**WOODMEN HILLS METROPOLITAN DISTRICT
 REGIONAL WATER RECLAMATION FACILITY**
 NORTH/SOUTH BUILDING ELEVATIONS

Project No.:	112.88
Scale:	AS NOTED
Date:	05/22/17
Design:	RMM
Drawn:	RMM
Check:	JPM
Revised:

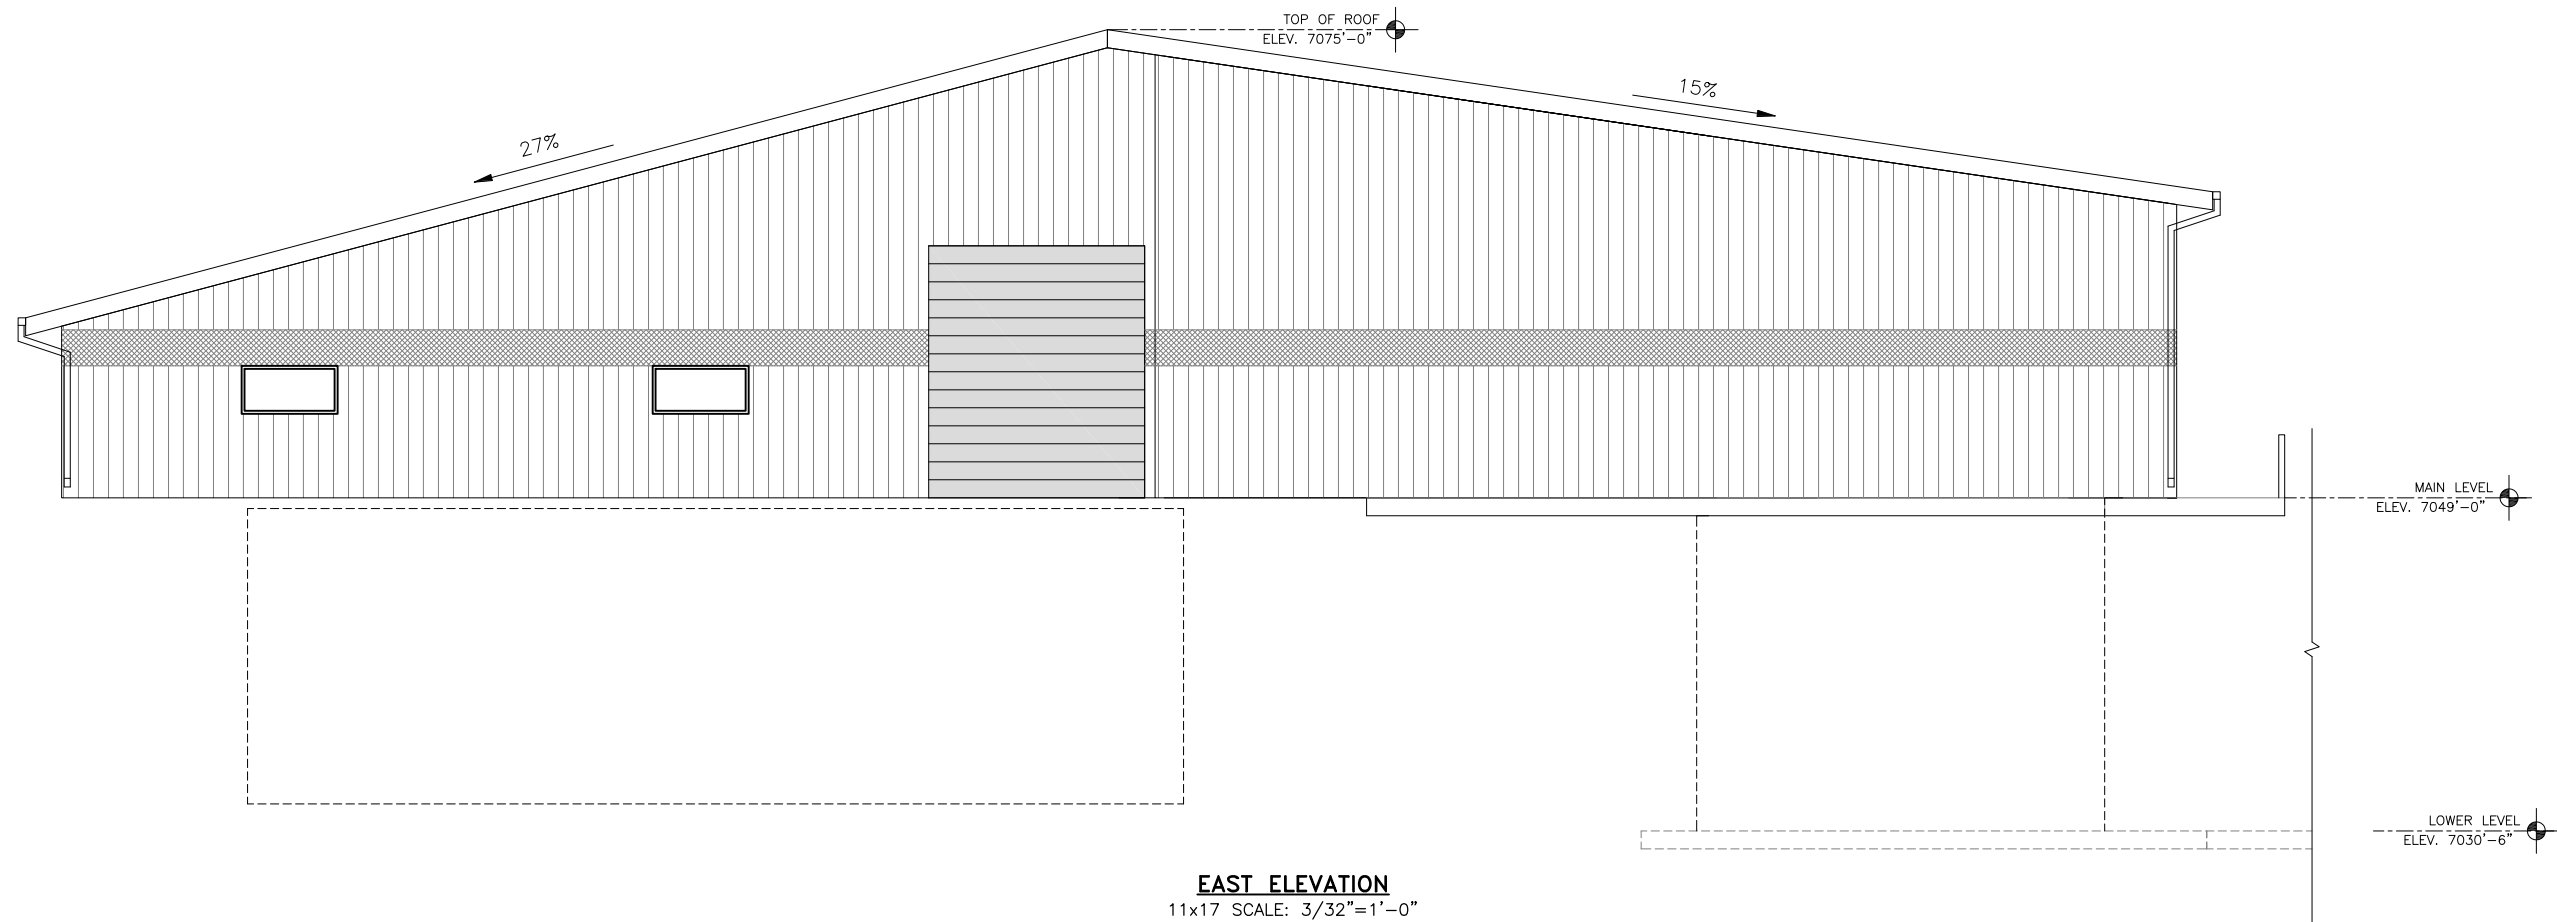
Add bar scale.

NORTH ELEVATION
 11x17 SCALE: 3/32"=1'-0"
 24x36 SCALE: 3/16"=1'-0"

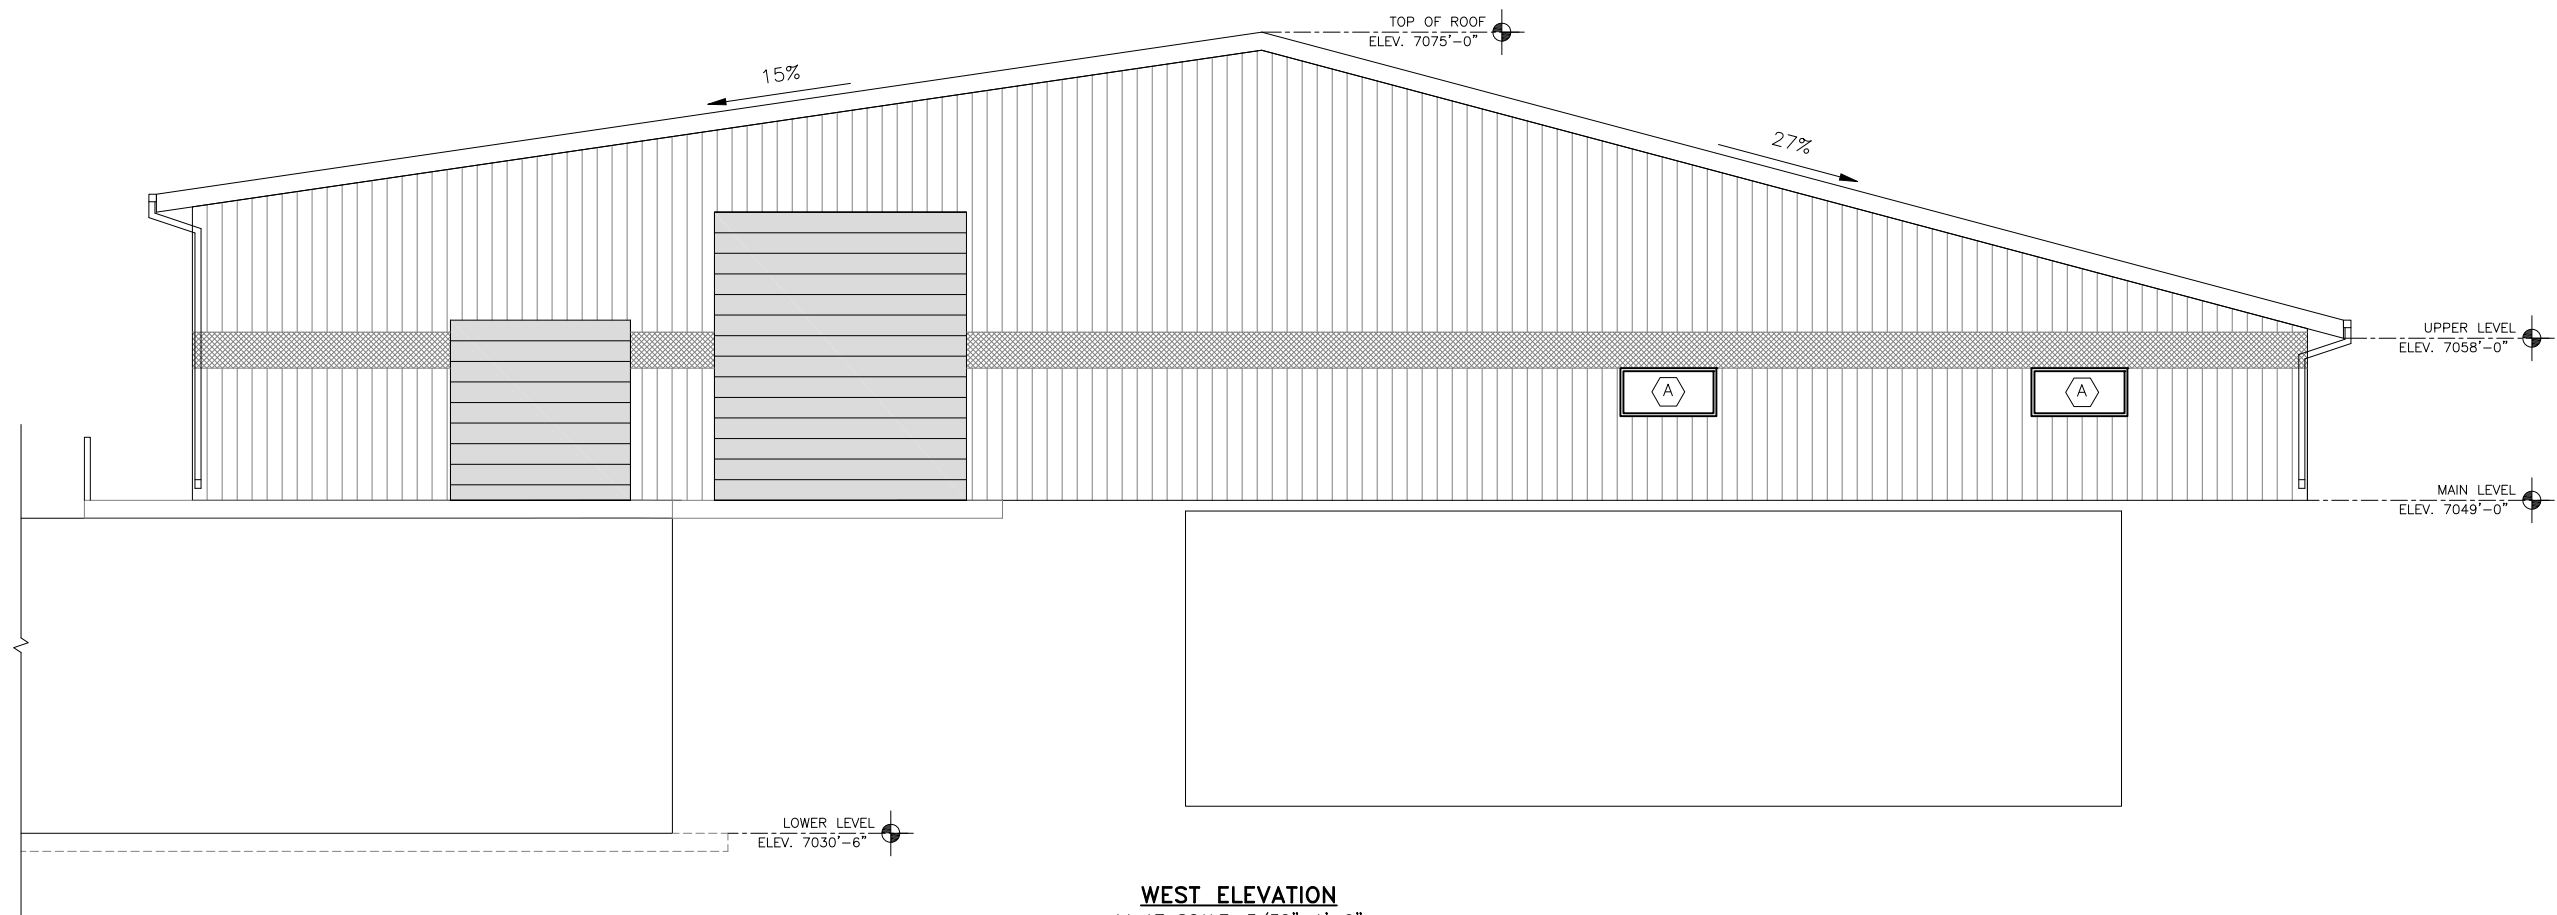
Revise the label to identify which face is the the south elevation.
